RE: Further Information Response in Relation to Planning Reference 24/61047 at The Johnstown Estate Hotel, Johnstown, Enfield, Co. Meath A83 V070.

Item Nos. – 1, 2 (a), 2 (b), 3 (a), 3 (b), 4 (a), 4 (b), 4 (c), 4 (d), 4 (e), 5.

This further information response document has been prepared by Cronin & Sutton Consulting Engineers (CS Consulting) on behalf of the applicant Lefgem Limited in relation to Planning Reference 24/61047 at The Johnstown Estate Hotel, Johnstown, Enfield, Co. Meath A83 V070.

This document addresses engineering related items of the request for further information issued on the 31st of January 2025 by Meath County Council (MCC) in respect of the above development application.

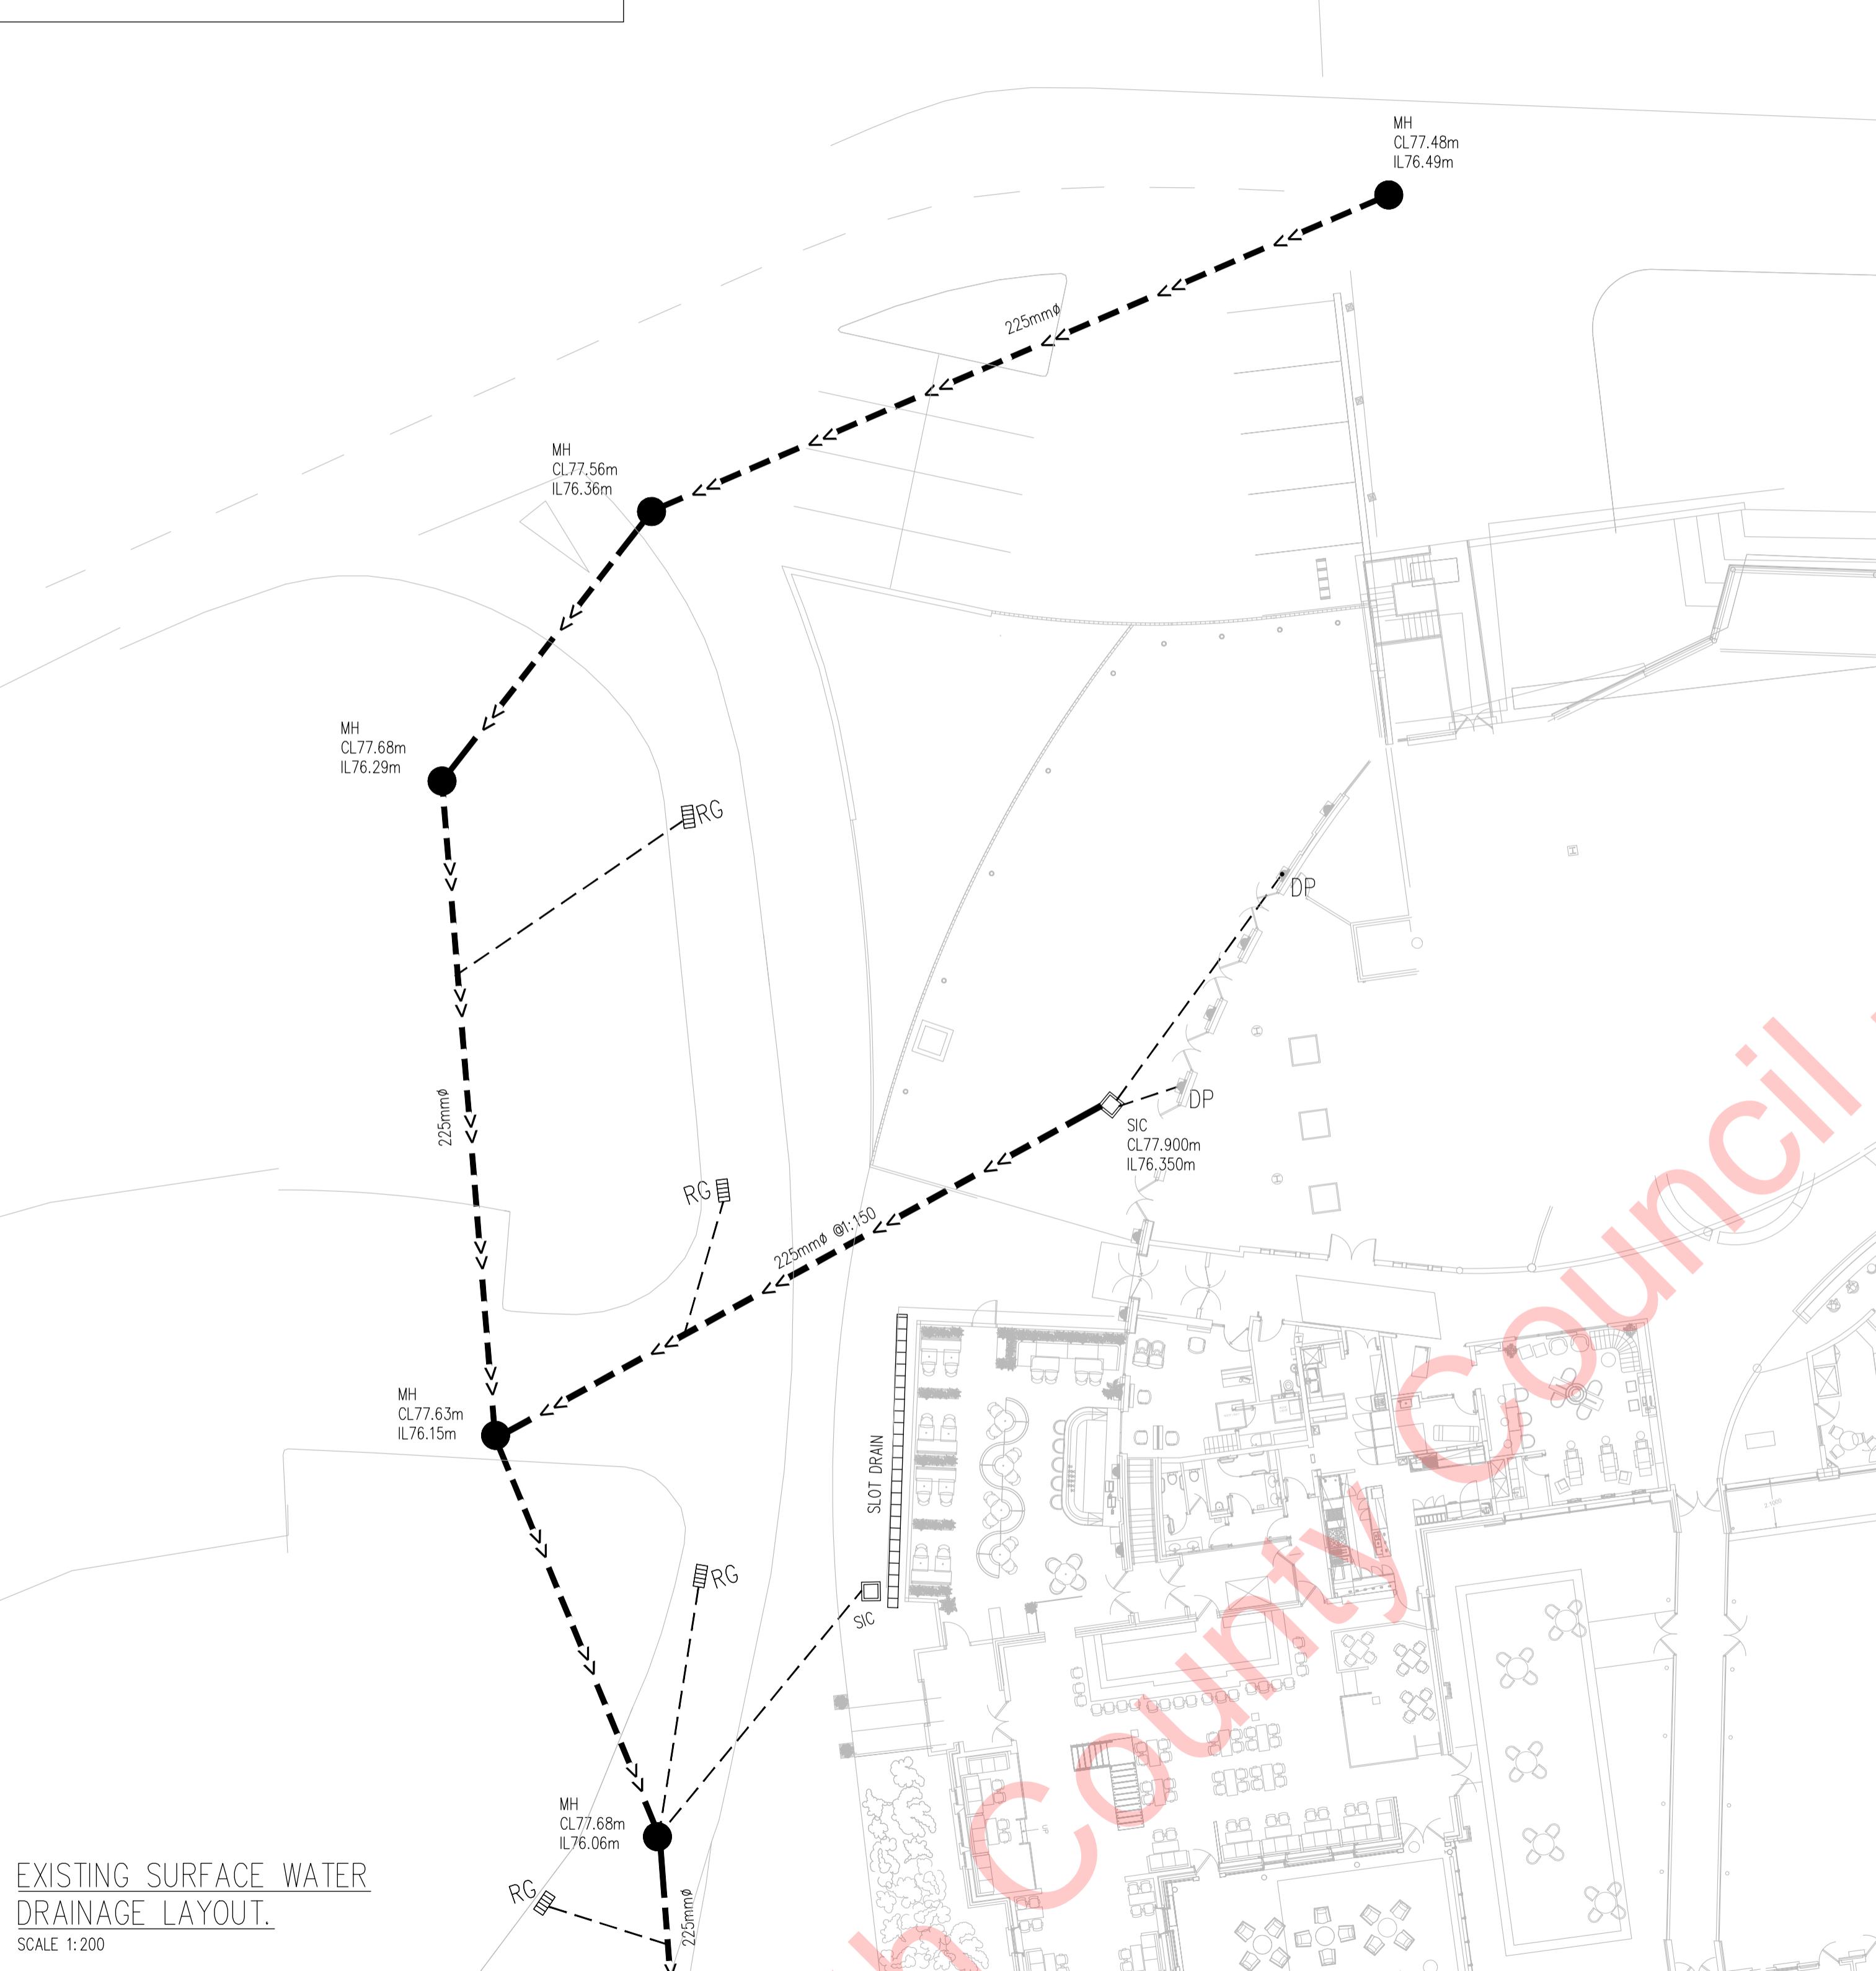
(a) The documents submitted by the applicant regarding surface water & foul are all submitted as draft documents. The engineering services report is not complete and has spaces left for comments. The applicant is therefore requested to re-submit all documents that are marked as draft and revise them up to planning status.

In response to this item, we submit updated **Engineering Services Report** and **CSC Drawing No's L118-CSC-ZZ-XX-DR-C-0106 Existing Restaurant Upgrades – Surface Water Drainage Layout** and **L118-CSC-ZZ-XX-DR-C-0110 Proposed Storm Water Drainage Layout**.

As a part of the proposed extension the existing rainwater downpipes located on the façade of the existing restaurant and the existing surface water drainage manhole located within the footprint of the proposed extension will be decommissioned. New rainwater downpipes located on the façade of the proposed extension will be provided and these rainwater downpipes will be connected to the existing surface water drainage system similar to the existing arrangement. Proposed restaurant surface water drainage layout is illustrated on CS Consulting Drawing No **L118-CSC-ZZ-XX-DR-C-0106**.

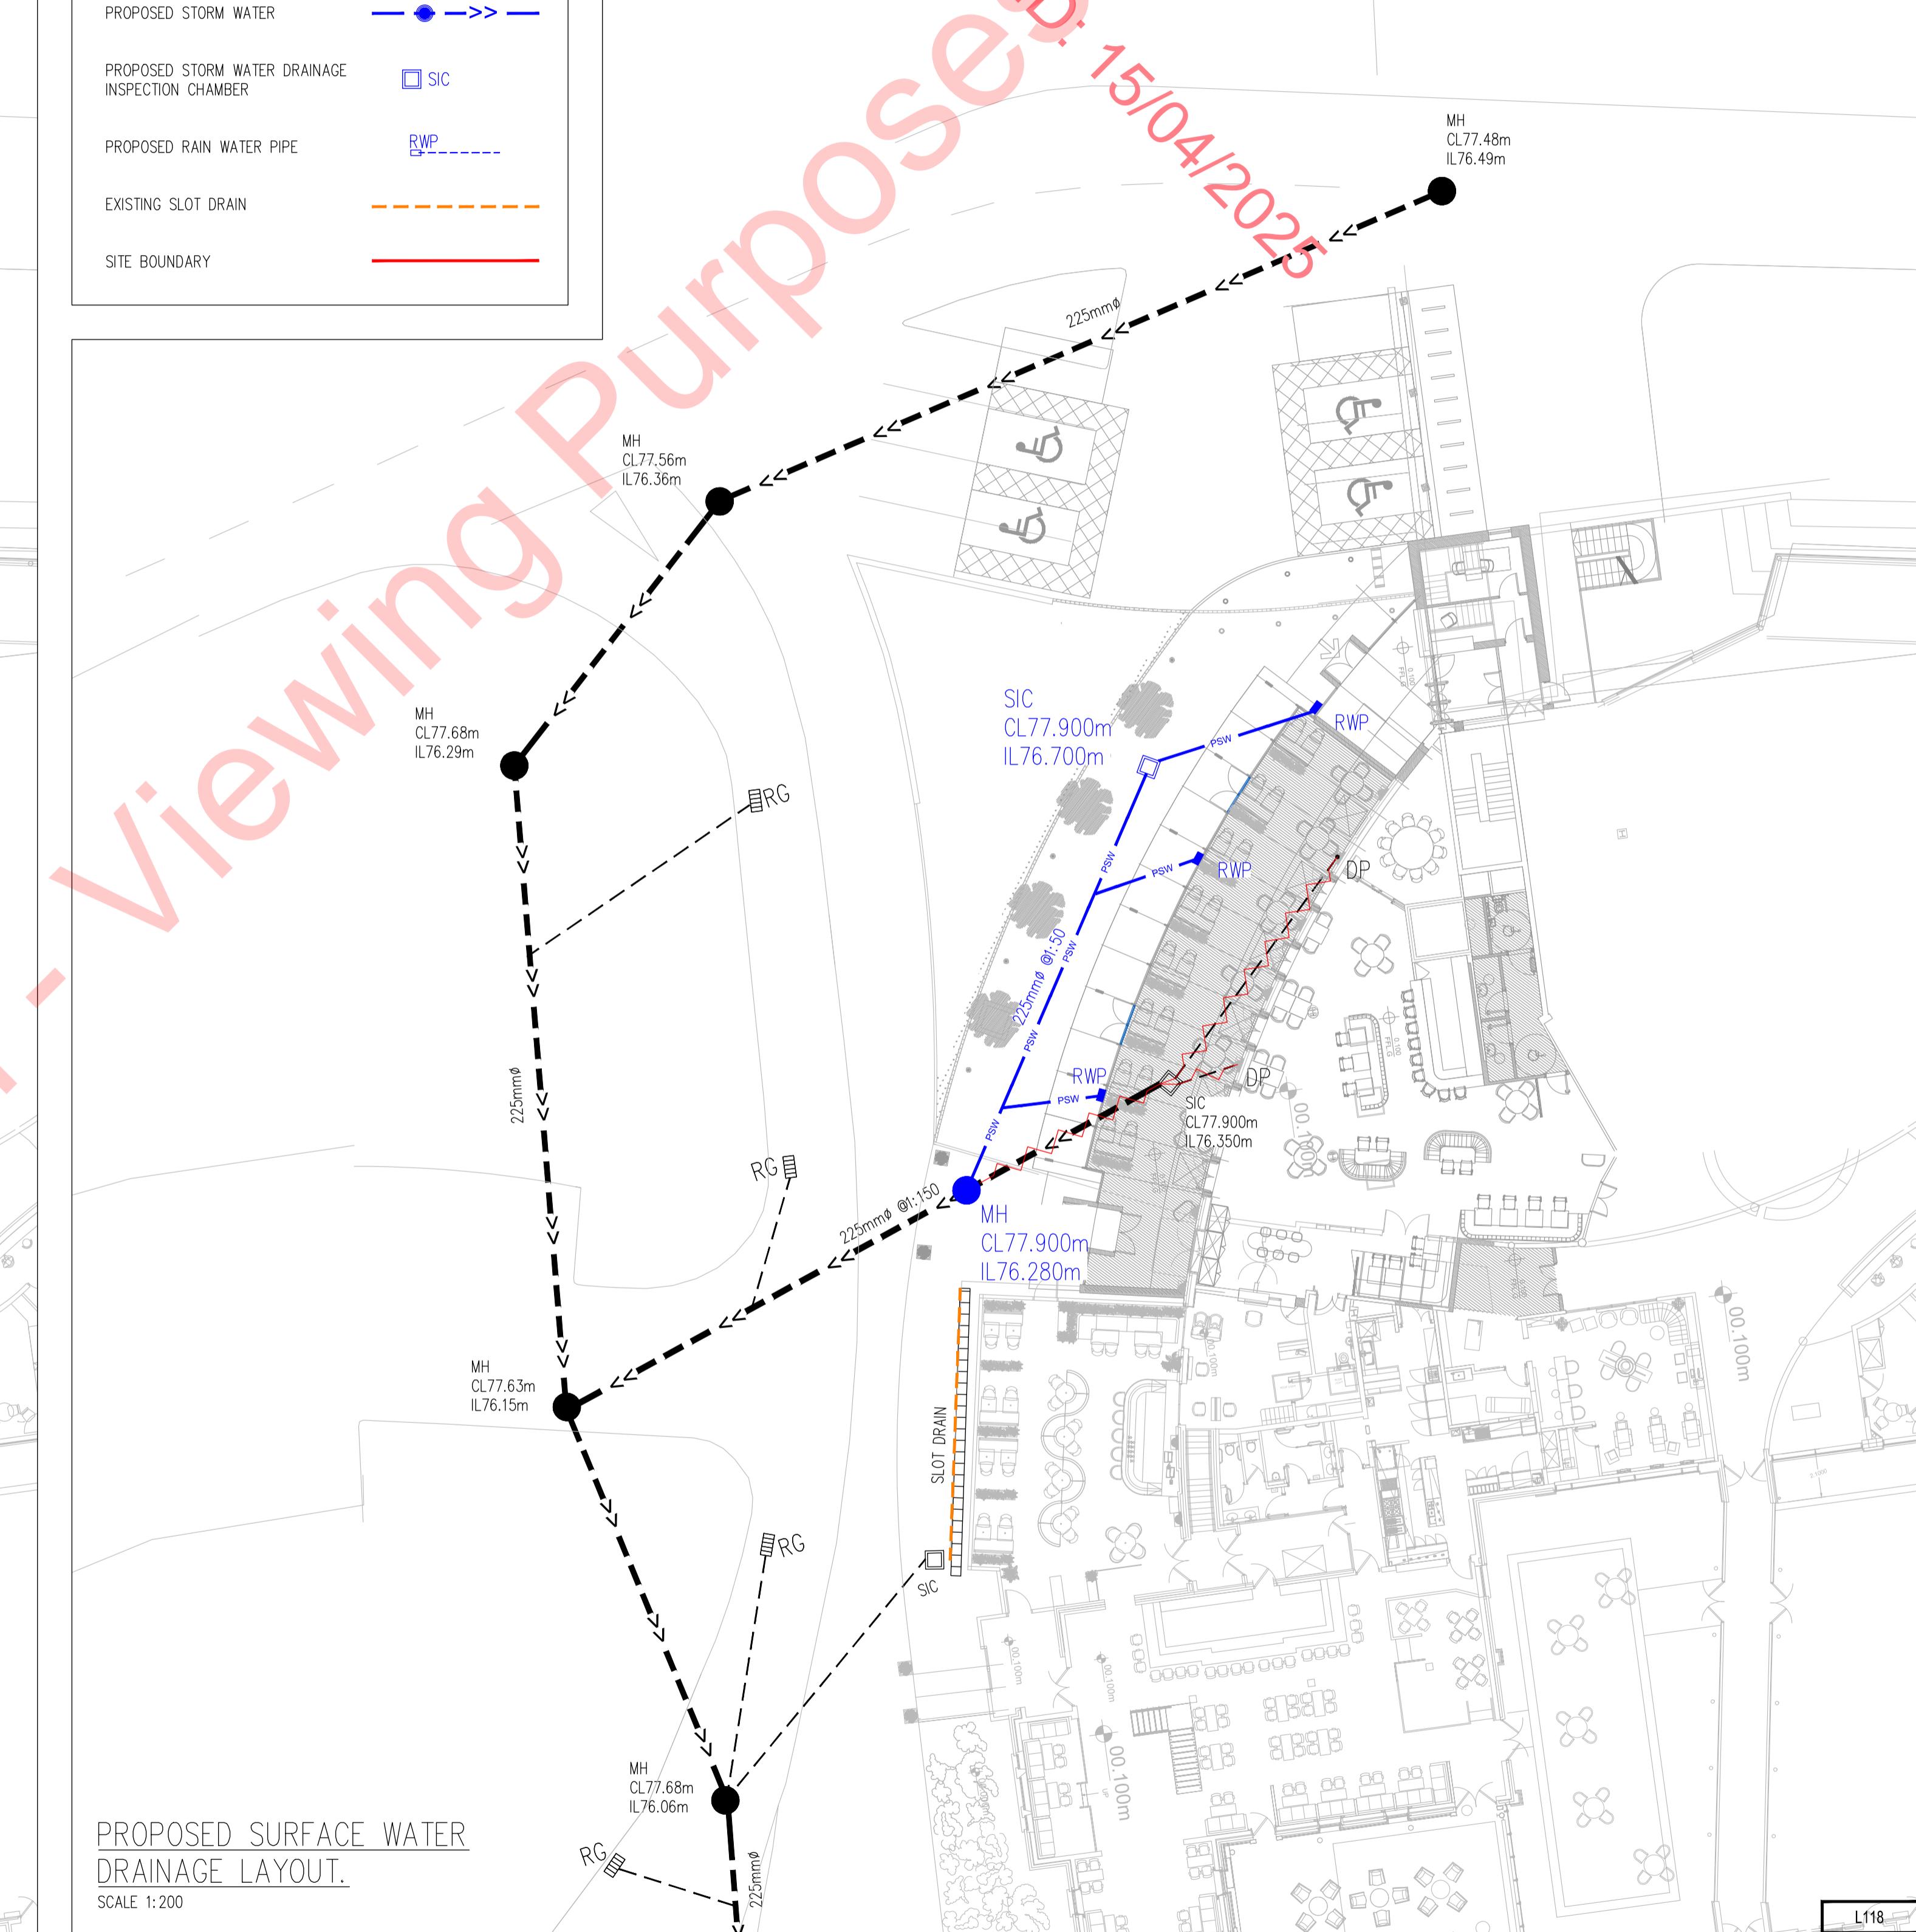
(b) The applicant has submitted a surface water design that does not comply with Meath County Council's requirements for the treatment of surface water. The submitted surface water design is not detailed sufficiently for the planning authority to carry out a thorough assessment. The applicant is therefore requested to submit a revised surface water design and system that is SuDs compliant and that is in accordance with the below mentioned guidelines.

(d) The applicant is requested to submit details of any existing surface water infrastructure that is proposed to be used as part of the subject development.

In response to this item, we submit updated **Engineering Services Report** and **CSC Drawing No L118-CSC-ZZ-XX-DR-C-0110 Proposed Storm Water Drainage Layout**.

In response to this item, we submit **CSC Drawing No L118-CSC-ZZ-XX-DR-C-0110 Proposed Storm Water Drainage Layout.**

However, given that the area footprint of the proposed bedroom block extension is limited to 0.2ha the related Q_{bar} figure was of order 0.5 l/s which in turn equated to an orifice on the flow control device less than 40mm. This size of orifice would be prone to blockage therefore an adequately sized flow control was sized and the associated discharge rate of 2 l/sec has been adopted.

Restricting storm water outflow to 2.0 l/sec/ requires that attenuation be provided for the predicted 1-in-100-year critical storm event (as increased by 20% for the predicted effects of climate change). The storm water attenuation volume to be retained on site has been estimated as 98m³.
